30/13-97A 4720 Waverly Avenue
Garrett Park Historic District

Case Number: 30/13-97A (REVISION)

A Historic Area Work Permit was approved at the June 11, 1997 HPC meeting for a new house and garage. Construction of the house has begun, but the applicant has requested a number of modifications to the approved HAWP.

Revised Site & Building Plans

WAVERLY STREET

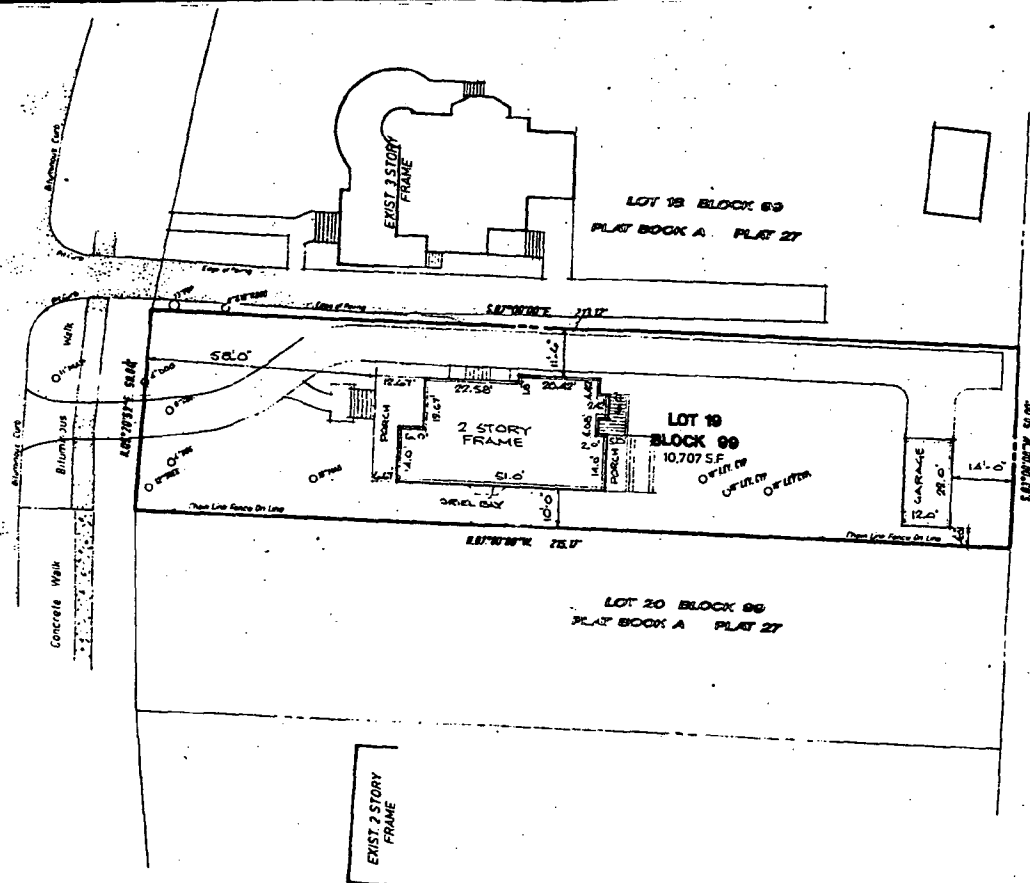
2) Changes in tree location due to garage relocation should be approved by staff.

1. Move the garage site to the right such that the distance from the property line is reduced from 12', as approved, to approximately 4' in order to provide room for a larger paved turnaround area at the garage entrance. Applicant has indicated that no trees will be affected by this revision.

As applicant has indicated that the revised garage siting will not affect any trees. Staff would emphasize that tree protection measures included as a condition of approval of the HAWP would continue to apply. The applicant had indicated in the previous application that trees were being relocated to the proposed new site for the garage. For clarification, the revised relocation for the maple and pin oak should be included in the current proposal.

1. All appropriate tree protection measures shall be used for trees that are to be retained, including installation of protective fencing at the driplines during construction,
2. Changes in tree locations necessitated by the garage re-siting shall be included in the current HAWP.

Currently Proposed Right & Rear Elevation

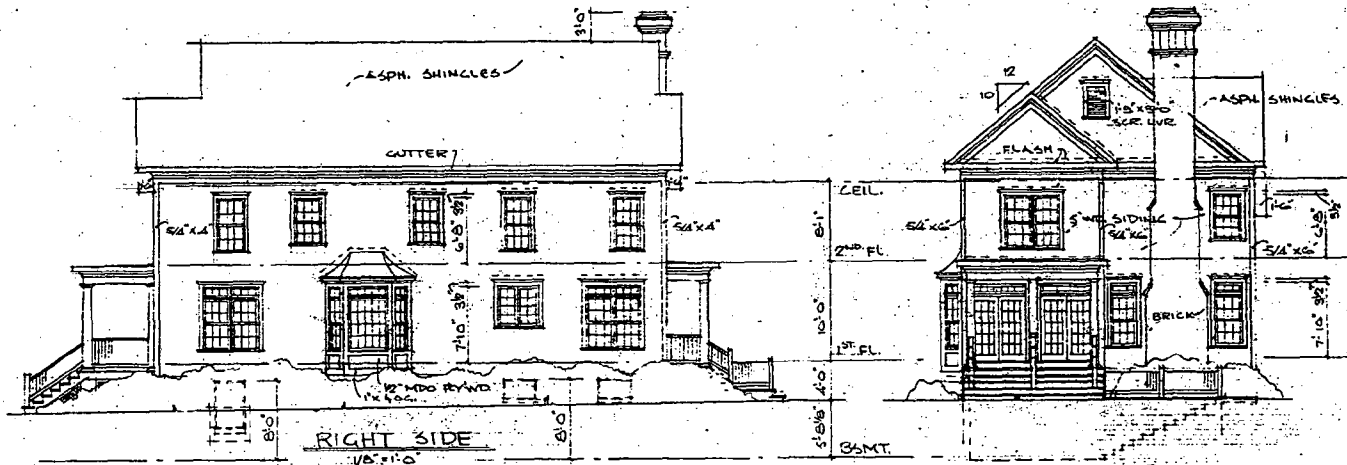
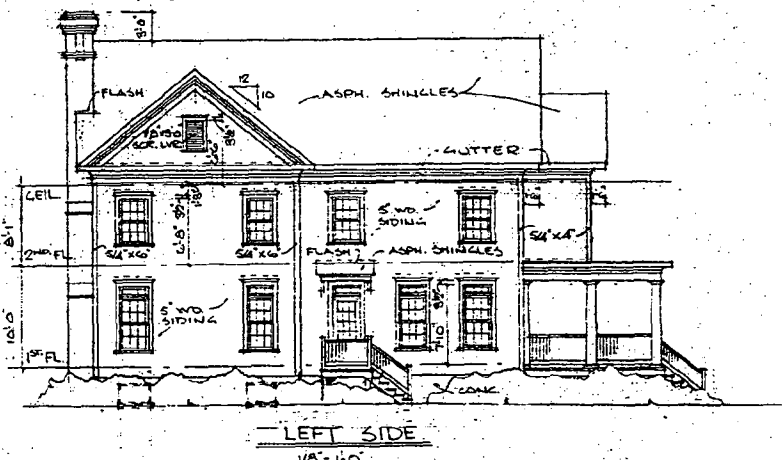
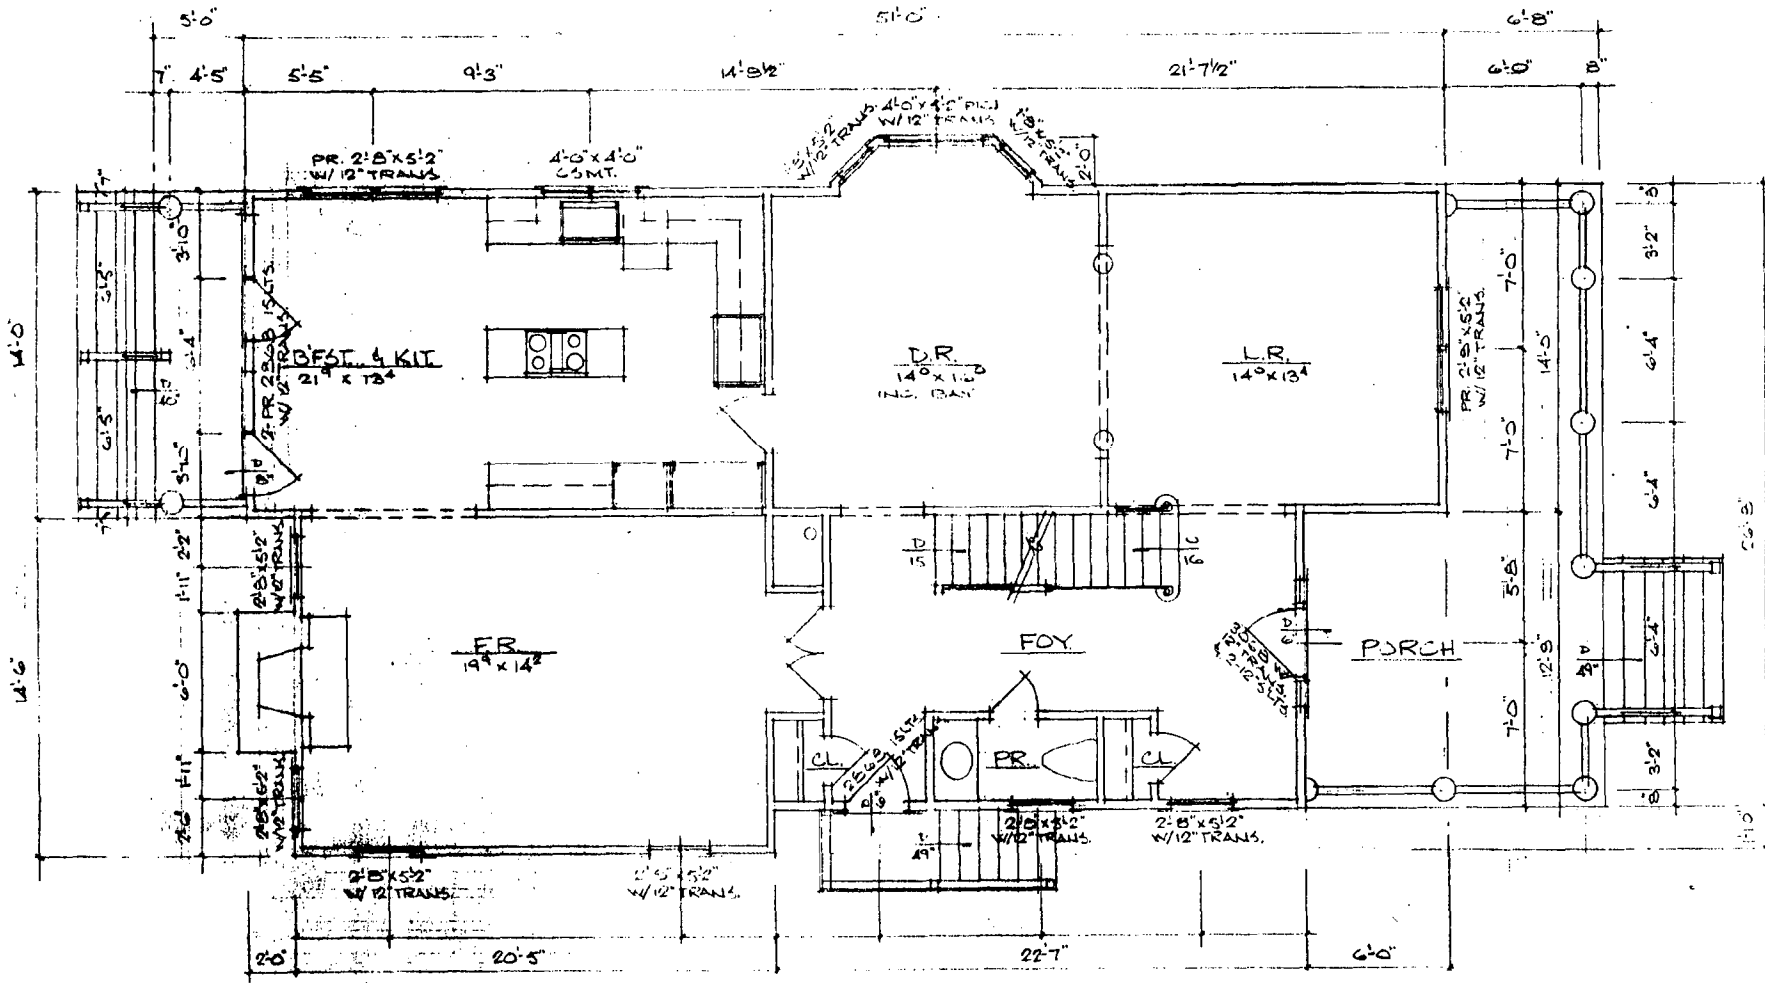
2. Add windows on the front of the right elevation. These include a 6/6 window on the second story and a banked pair of 9/6 windows to match those at the rear end of the elevation. The windows are to match those already approved as to design and materials.

Staff would support the addition of windows to the right side facade. Those being proposed are in keeping with the placement, design and materials of the other windows on that side.

Currently Proposed Floor Plan (Basement)
9-10-97

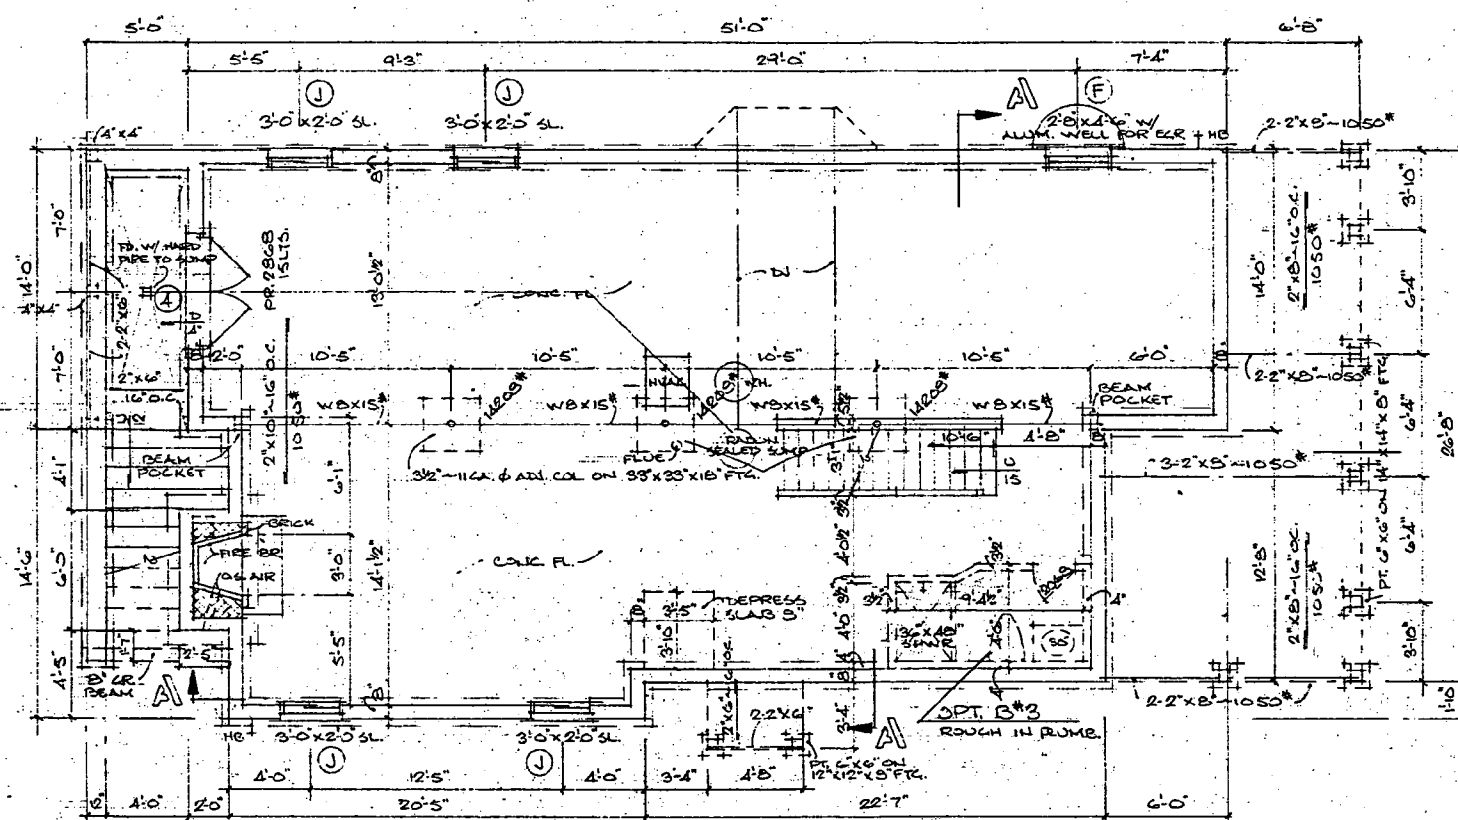
4. Install an exterior entrance to the basement level at the rear next to the rear porch. The entry steps would be of brick with a railing at ground level.

88-17-97 ADD AREAWAY

FIRST FLOOR PLAN

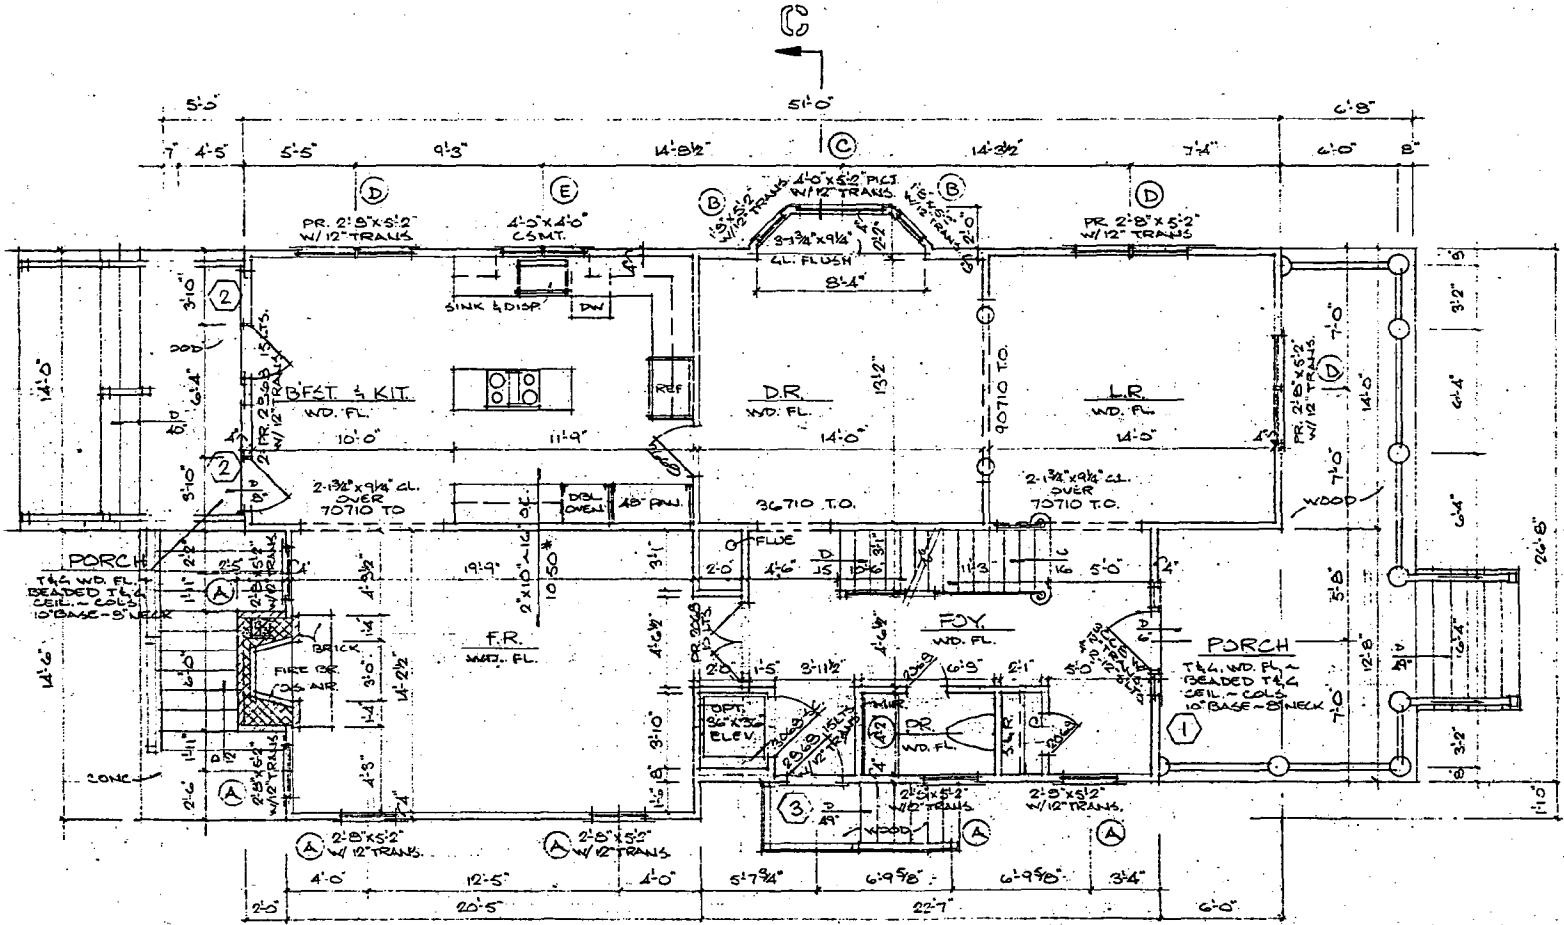
3. Modify the design of the back porch, adding a landing one step above ground level. The deck will be of the same design and material as the approved porch including wood railing with inset pickets.

B-17-97	ADD AREAWAY
	ADD PORCH LANDING
	ADD LR WINDOW

SECOND FLOOR PLAN
1/4"=1'-0"

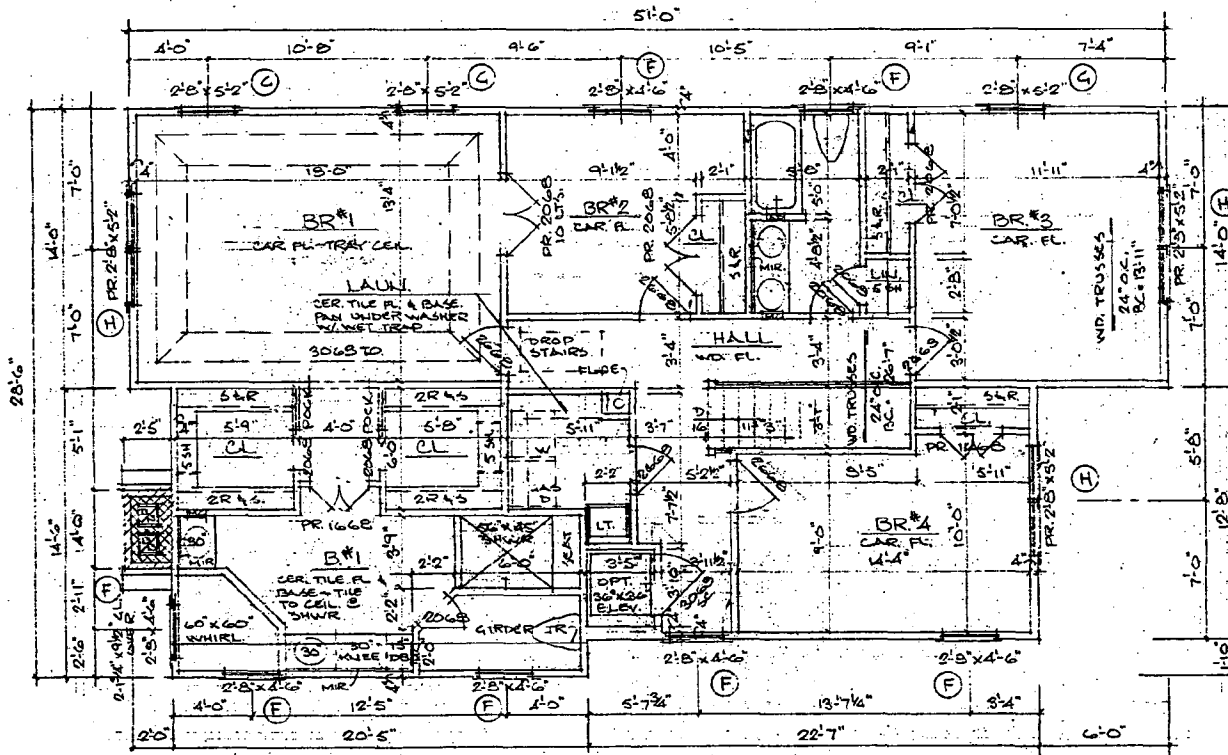
8-17-97 ADD BR #2 WINDOW
